# Certificate of Appropriateness

### 1843 N. Palmer Street, Brewers Hill Historic District

## Date issued 7/12/2023

1 FRONT PORCH - FRONT ELEVATION  
1/4" = 1'-0"

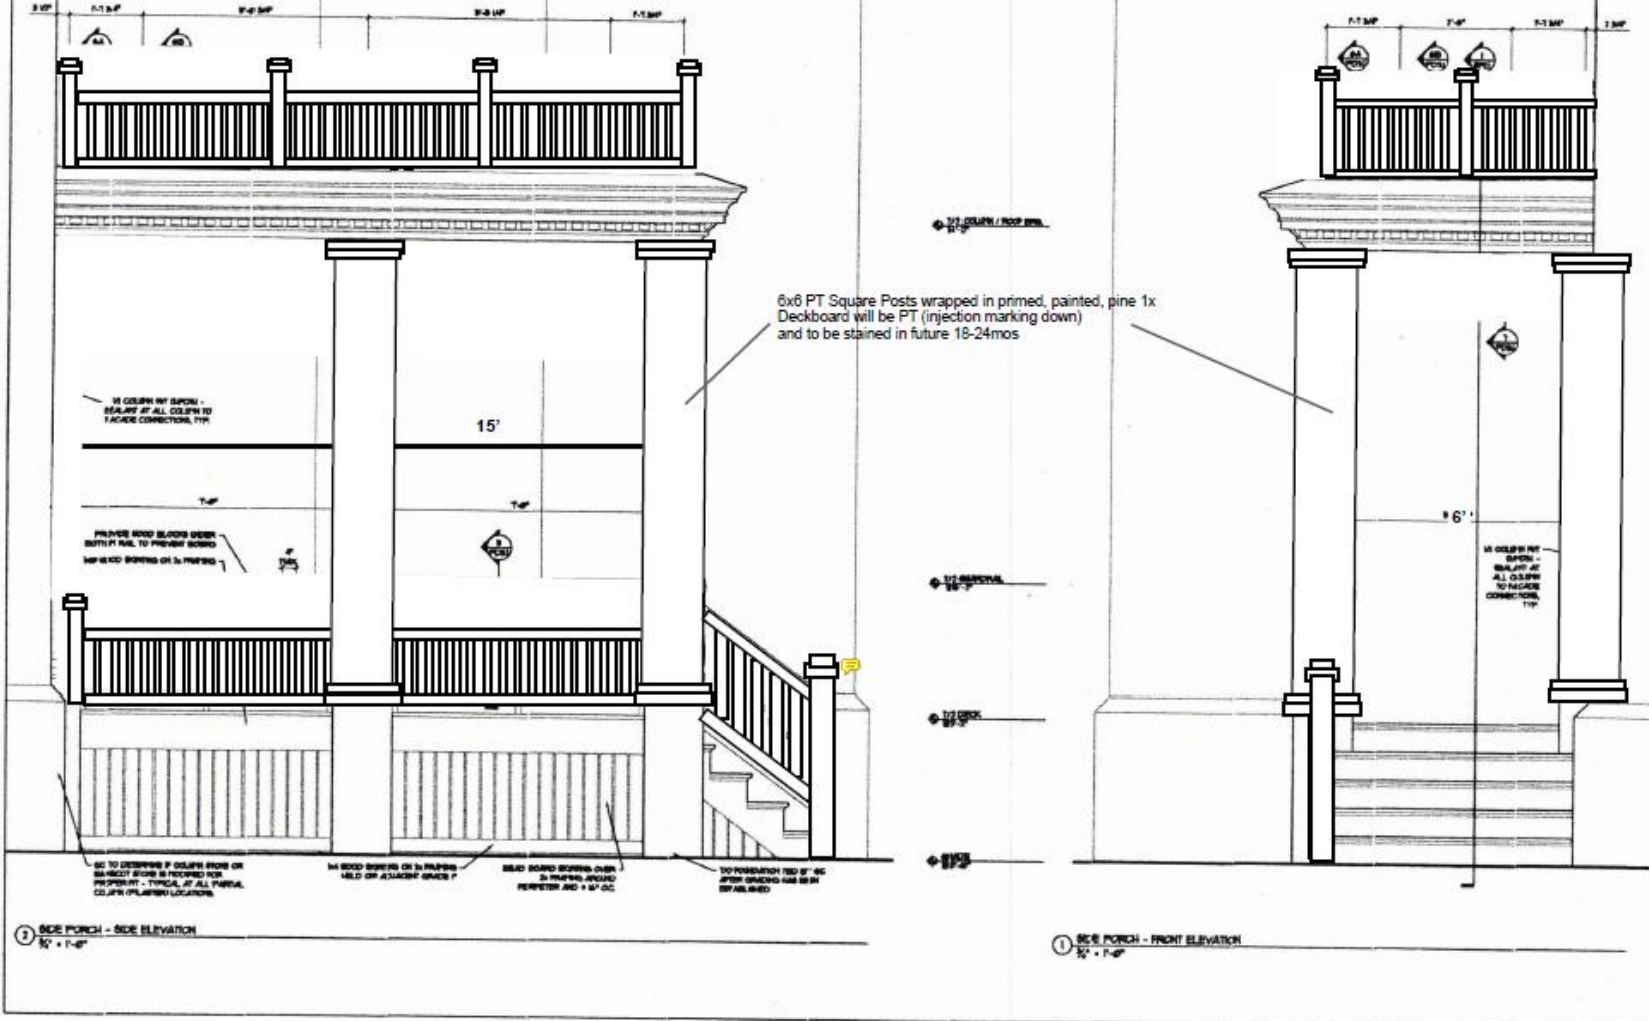
**2-1/4" wide center match or tongue-and-groove decking to be stained within 12 months.**

**All finish wood must be smooth and free of knots and must be painted or treated with an opaque stain upon completion. Note: when new, bare wood is left exposed to the exterior elements for a period of only a week or two, the life of the paint job subsequently applied to it will be decreased. The use of a decay-resistant wood for is required for porch areas. Using western white pine or Ponderosa pine is "at your own risk" because this wood has no natural decay resistance and can deteriorate in some exterior settings in just a few years.**
